NFPA 805 OBSERVATION VISIT TRIP REPORT

Date: May 30 - June 1, 2007

Subject: Risk-Informed, Performance-Based Fire Protection Transition Pilot-Plant Observation Visit – Progress Energy Corporate Headquarters, Raleigh, North Carolina, and New Horizons Fellowship Center in Apex, North Carolina

Figure 1. Multiple Spurious Post-Transition Inspections

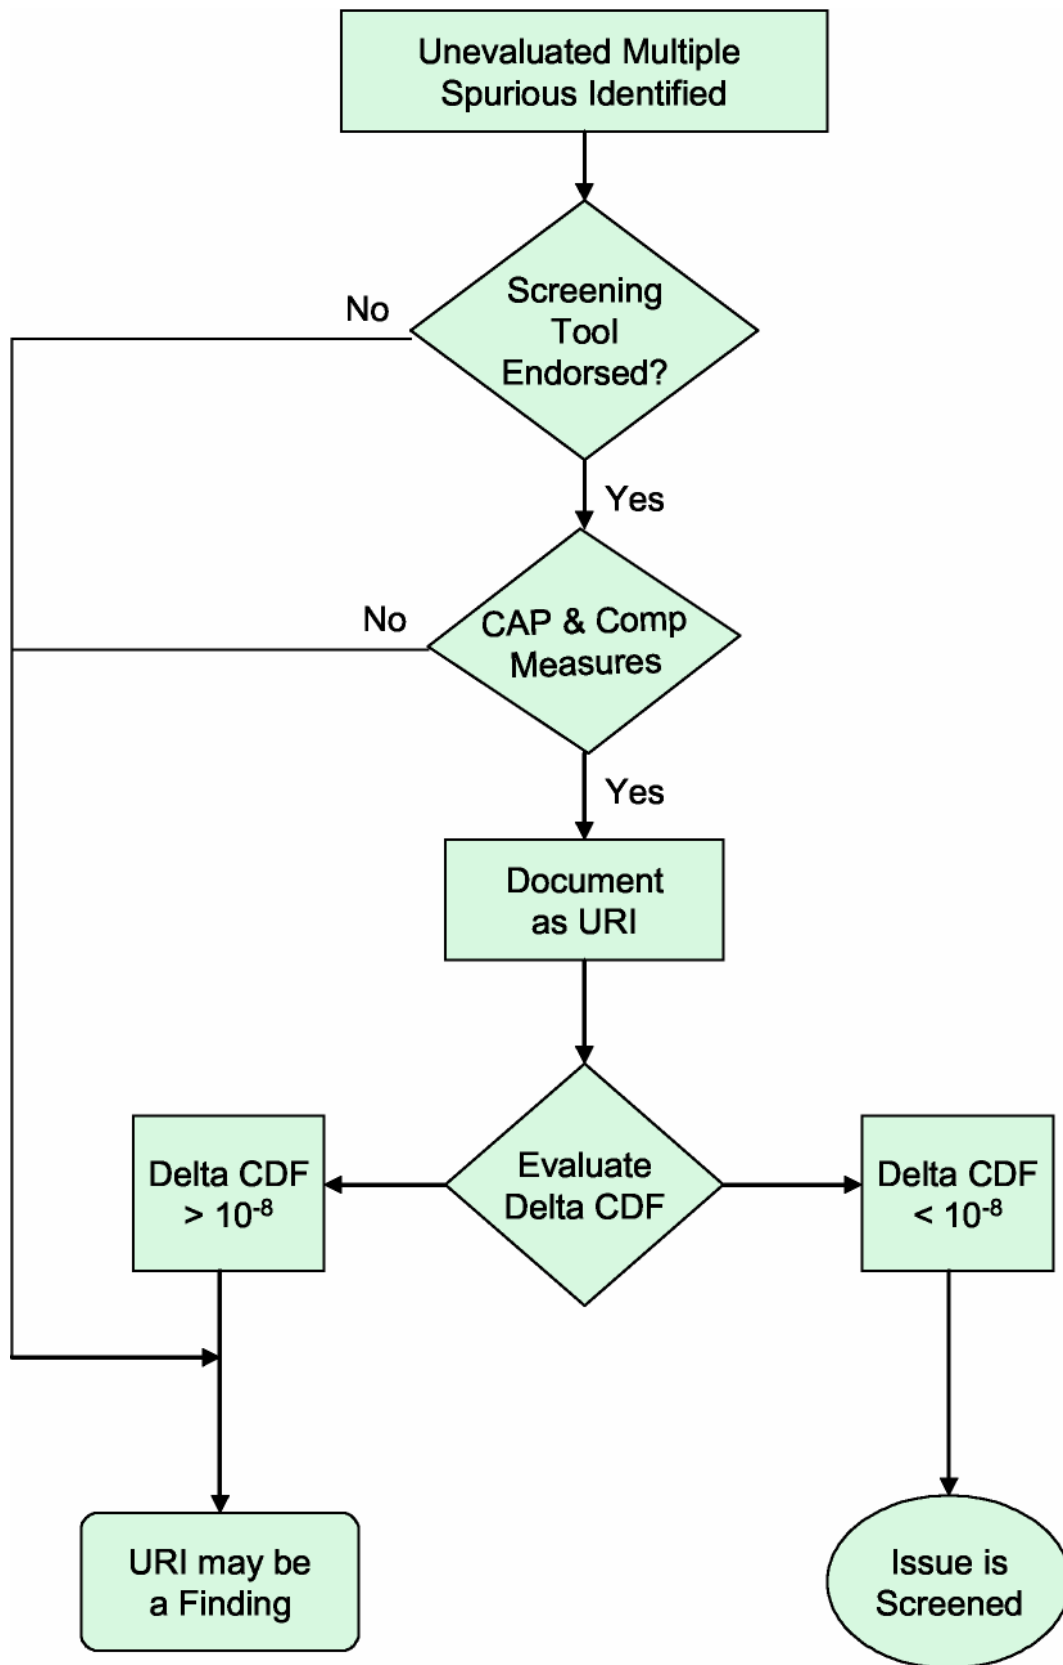
At the March 2006 pilot plant observation visit, the Staff presented a flow chart, illustrating how newly found multiple spurious circuits identified during an inspections, could be treated (See flow chart below). In addition to the flowchart, the following information was discussed:

Resolution Action(s)/Action Party: OPEN. Industry and pilot-plant participants agreed to review the flowchart, IMC 0612 questions, screening thresholds and provide feedback to the NRC at the next observation meeting. The industry may also submit an FAQ on the issue.
